INDESIT company

Model type:
IDL55SDE.2

Commercial code:
F032224

N1045072FIG1

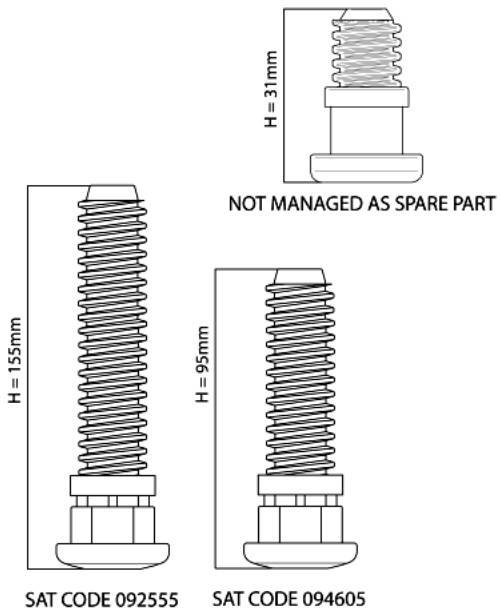
N1045072: Introduction of fixed rear foot H=31mm on free-standing models.

From serial no. 40218.0001, free-standing dishwashers affected by this modification have been equipped with new fixed rear feet (H=31mm).
The new foot replaces the adjustable one (H=155mm) Service code 092555; on the EVO3 range with TurboDry the new foot replaces the adjustable foot (H=95mm) Service code 094605.
The Spare Part Warehouse will continue to manage only 155mm and 95mm adjustable feet as they are interchangeable with the fixed 31mm foot.
The three feet are shown in illustration N1045072FIG1.

N1045083FIG1

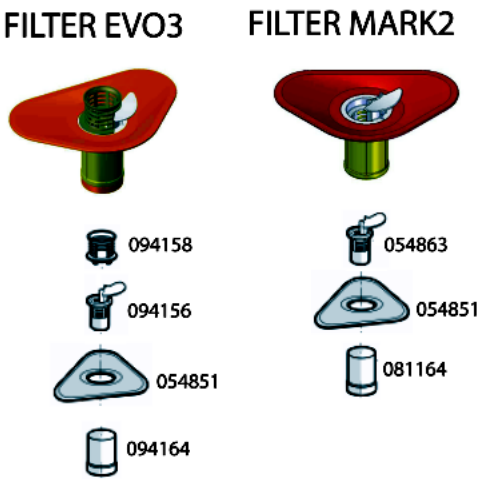
n1045083: Modification of filters on EVO3 60 cm dishwashers

All dishwasher models affected by this modification have been equipped with the items listed below, in order to solve the drain pump clooging problem.

Introduction of:
Cylindrical plastic filter code 081164
Central filter code 054863

Elimination of:
Cylindrical plastic filter code 094164
Central filter code 094156
Central filter grid code 094158

The modification has been introduced progressively, starting from serial no. 40516.0001.

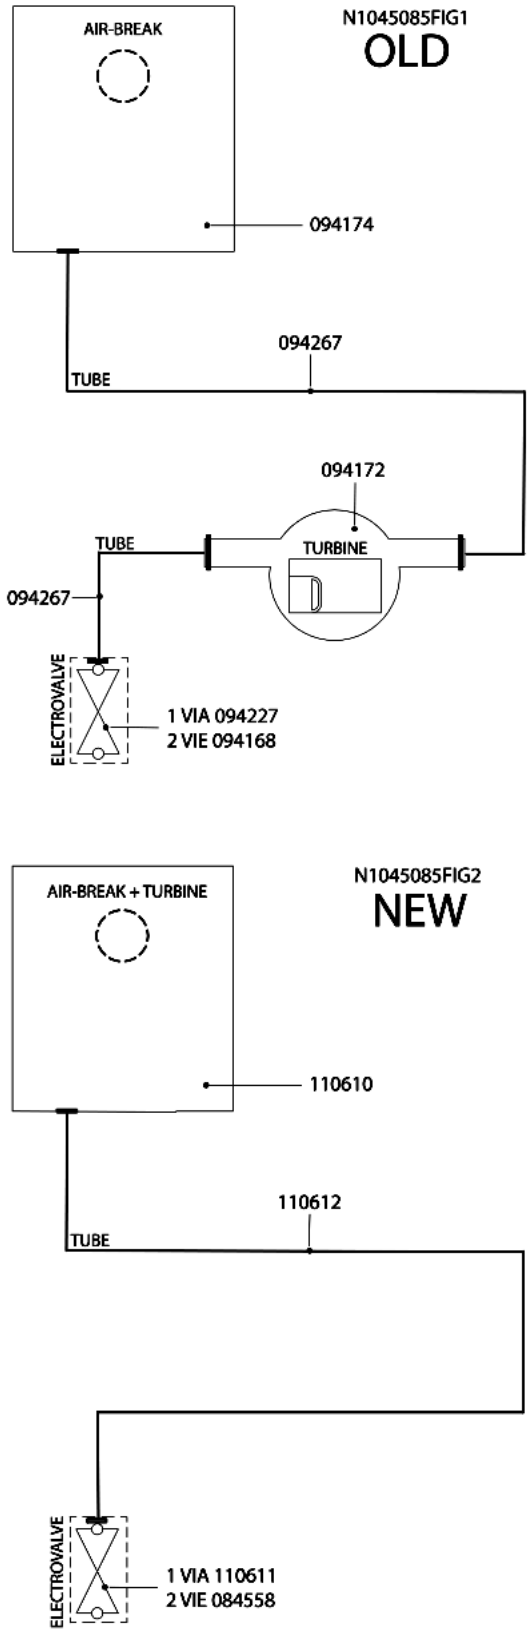
n1045085: Introduction of new litre counter turbine integrated on air-break.

All dishwashers affected by this note have been equipped with a new litre counter turbine on the air-break.
Picture N1045085FIG1 illustrates the premodification structure, picture N1045085FIG2 the new structure.

AIR-BREAK:
new 110610;
premodification 094174;
the new item features a new integrated litre counter turbine and its water supply hose has a smaller diameter.

LITRE COUNTER TURBINE code 094172 has been eliminated.

SOLENOID VALVES:
new:
1-WAY code 110611;
2-WAY code 084558(Rohs 143737);
premodification:
1-WAY code 094227;
2-WAY code 094168;
the new solenoid valves have a smaller diameter drain hose fitting.

HOSES:
new solenoid valve hose/air-break code 110612;
premodification turbine hose/air-break code 094267;
premodification solenoid valve hose/air-break code 094267;
the new hose has a smaller internal diameter.

WIRING:
the litre counter turbine connecting cable is longer, but since the connector is the same, the new item can be used in place of the premodification one.

N1045133/134FIG1

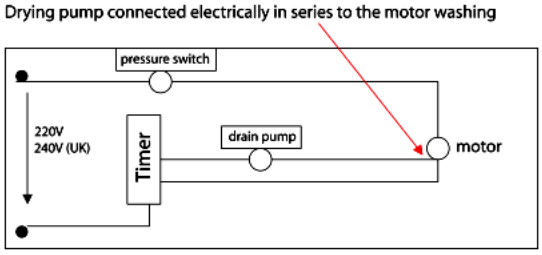
The drain pump electrical connection has been modified from a configuration in series with the wash electric pump to one in parallel.

The drain pump in series with the wash electric pump is fed through the wash electric pump causing a voltage drop equal to -15V (diagram N1045133-134FIG1).

Drying pump connected electrically in series to the motor washing

N1045133/134FIG2

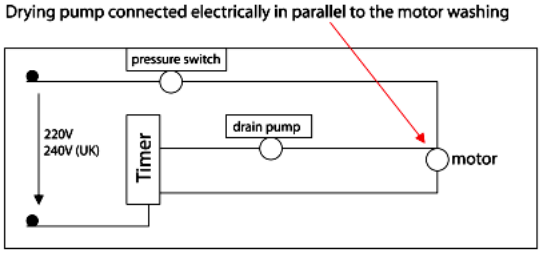
The drain pump in series with the wash electric pump is electrically fed directly by the F-N line, without any voltage drop (diagram N1045133-134FIG1).

Drying pump connected electrically in parallel to the motor washing

New parts:
Wiring in parallel
C00118767(Rohs 143766) - thermoprotected drain pump 220/240V 50HZ 26W - picture (N1045133-134FIG3)

Premodification parts:
Wiring in series
C00112306(Rohs 143739) - drain pump 230V 50HZ 22W - picture (N1045133-134FIG4)

Important!!
The thermoprotected drain pump cannot be installed on premodification dishwashers.
The non-thermoprotected drain pump cannot be installed on modified dishwashers.

N1045136FIG1

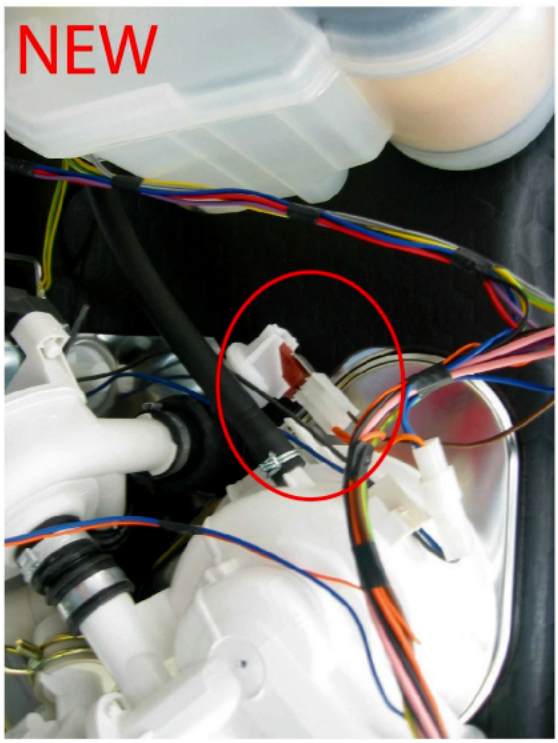
n1045136: introduction of new high pressure sensor

In modified products the connector going to the high pressure sensor is part of the wiring assembly (see picture N1045136FIG1).
In premodification products the high pressure sensor is connected to the wiring assembly by a cable that is part of code C00094157 (see pictures N1045136FIG2-3).

New parts
Wiring
C00142435 - high pressure sensor

Premodification parts
Wiring
C00094157 - high pressure sensor + cable

The new parts are not individually interchangeable with premodification ones.
